17 June 2019

16457
CPo/SM

**SECTION 4.55(1A) MODIFICATION APPLICATION TO MP08_0238 (MOD 13)
1 DENISON STREET, NORTH SYDNEY**

Figure 2 Proposed Extract of Western Elevation

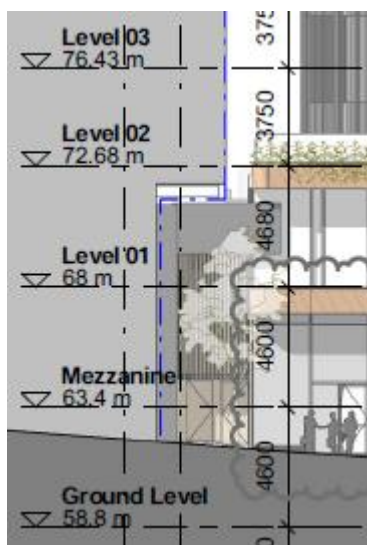
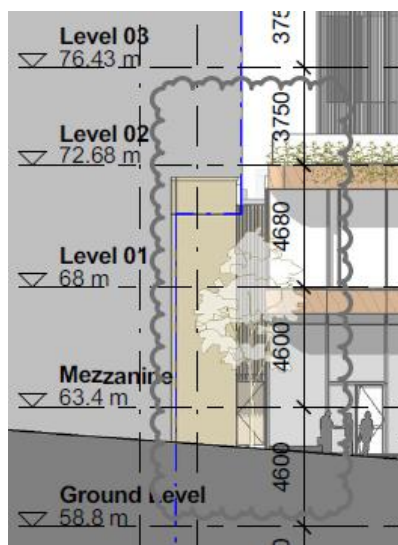
The proposed modification includes minor façade changes to extend the approved façade material to extend the precast panel on the western elevation for the Ground Level and Level 01. The façade changes are detailed on the proposed elevations provided in the Architectural Plans at **Attachment A**.
